State Significant Development Application – SSD-81434988
221-235 Luddenham Road, Orchard Hills
Alspec Warehousing Facility

17 September 2025

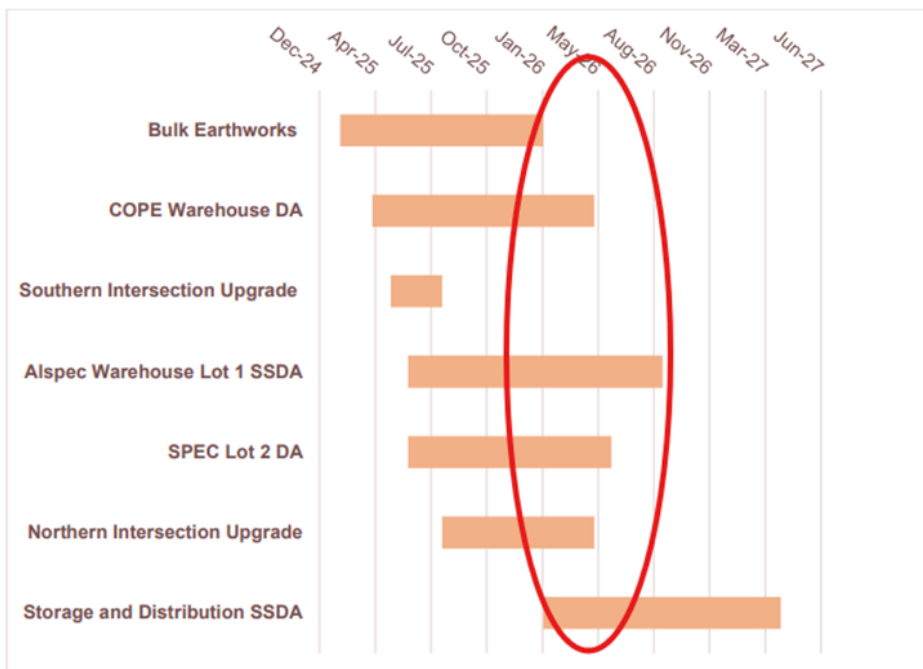
Comment: It is noted that 246 parking spaces are being proposed, which exceeds the requirement of 194 spaces. A similar outcome was identified by Sydney Metro and raised against the previous SSDA that was lodged (SSD-69845208), with Alspec responding that the additional parking spaces is for future demand/development of the site. However, as per Figure 6, each warehouse development has their own parking facility.

Request the Applicant confirm what additional development they are referring to that would utilise the additional spaces for this development and SSDA-69845208. An oversupply of parking encourages additional single-vehicle trips, which in turn generates poorer traffic outcomes. Suggest the Applicant modify the volume of parking spaces to be more in-line with the required amount or confirm which future developments will utilise the additional parking spaces.
